RE: **ISOLATED PHOTODIODE**

Application No.: 10/044,974

REQUEST FOR APPROVAL OF DRAWING CORRECTIONS

FIG. 2

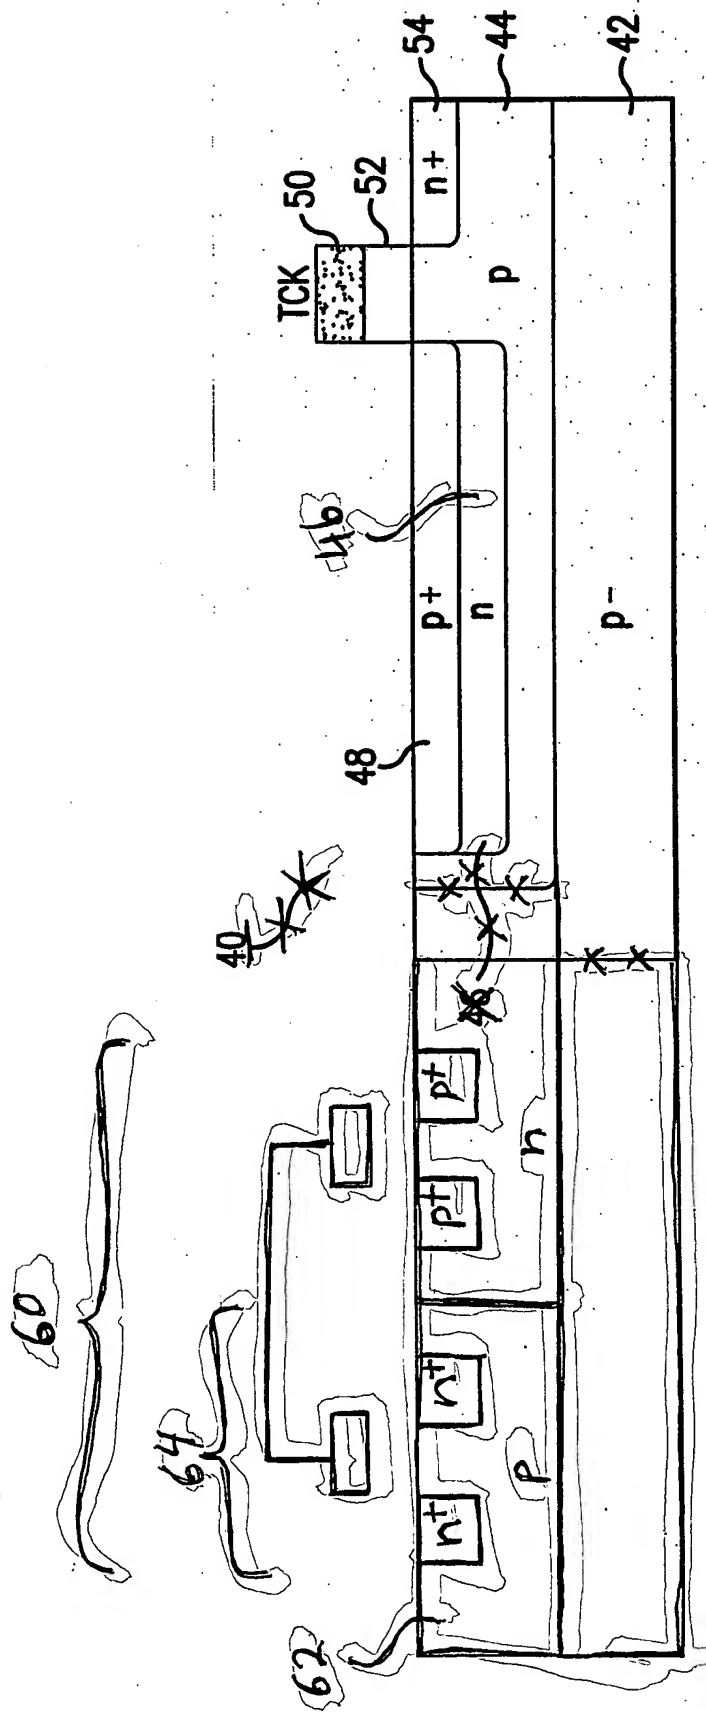
The corrections to FIGS. 1-3 correct original FIGS. 1-3 to conform the drawings to the specification. The specification, on pages 4 and 5 disclose: (1) sensor 10 as including CMOS circuitry (illustrated as circuitry 30), (2) sensor 40 as including CMOS circuitry (illustrated as circuitry 60), and (3) sensor 70 as including CMOS circuitry (illustrated as circuitry 90). Furthermore and referring to FIGS. 1-3, page 8, lines 8-15 of the specification discloses that at least one n-FET (illustrated as 34) are formed in a p well (illustrated as 32). The depiction of CMOS circuitry in proposed FIGS. 1-3 includes no more subject matter than what would be understood by a person of ordinary skill in the art from the disclosure of CMOS circuitry described on pages 4, 5 and 8. No new matter was added to the proposed corrections to FIGS. 1-3.

FIG. 7

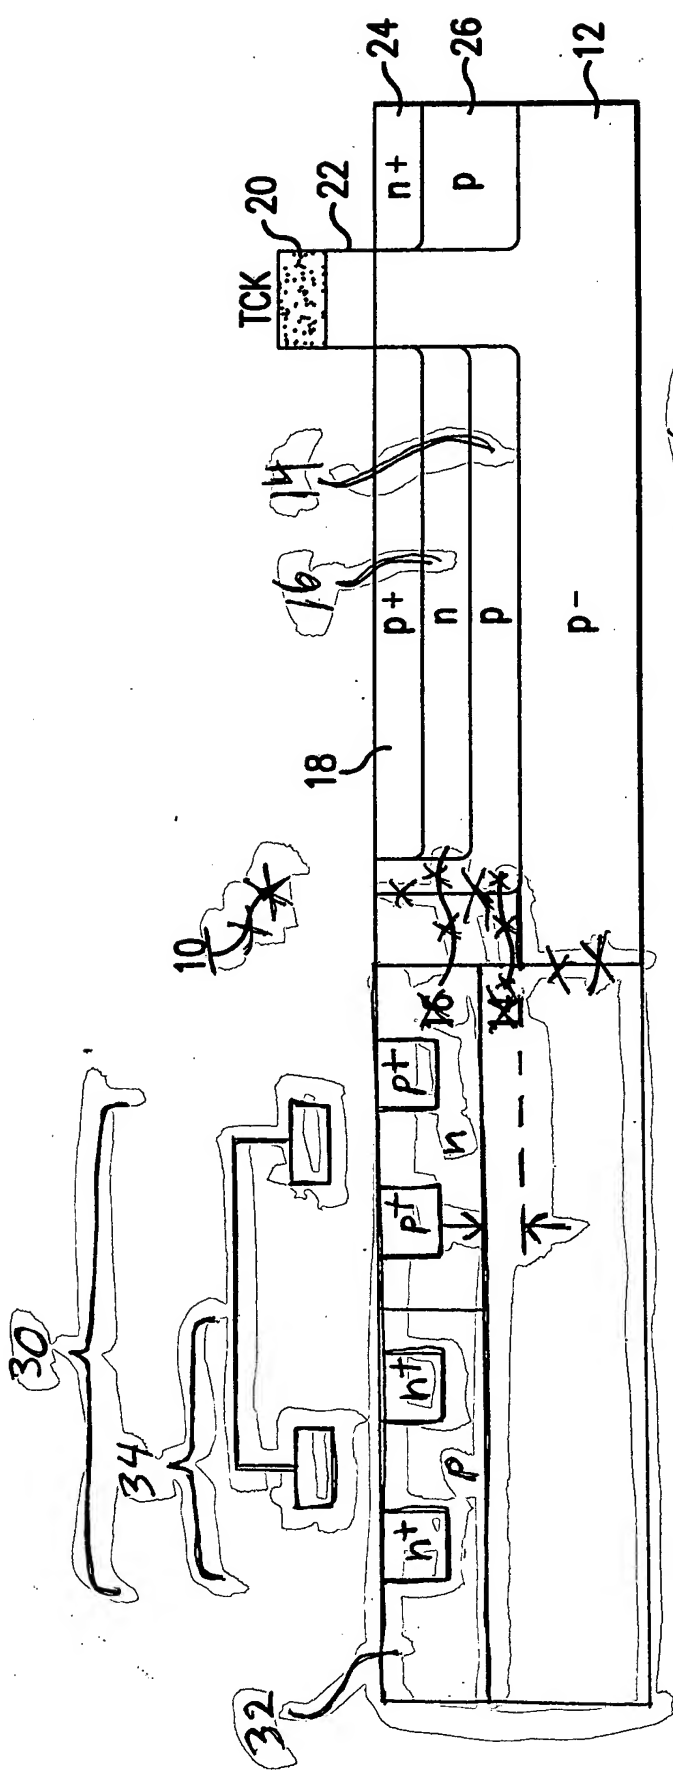
The additional FIGS. 7-9 are proposed to further conform the drawings, as a set, to the specification, as a whole. FIGS. 7-9 derive from the original disclosure of corrected FIGS. 1-3 and the original disclosure in the specification on page 8, lines 16-19 where the p implant

beneath the photodiode is increased in depth by an extra implant process beyond the conventional CMOS p well implant process. No new matter was added in the proposed additional FIGS. 7-9.

FIG. 10

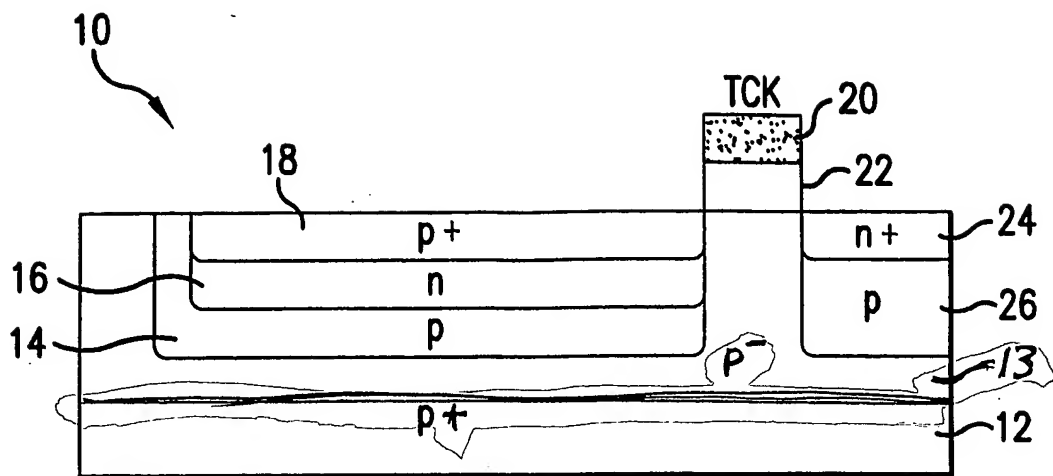
The additional FIGS. 10-12 are proposed to further conform the drawings, as a set, to the specification, as a whole. FIGS. 10-12 derive from the original FIGS. 1-3 and the original disclosure in the specification on page 9, lines 5-15. No new matter was added in the proposed additional FIGS. 10-12.
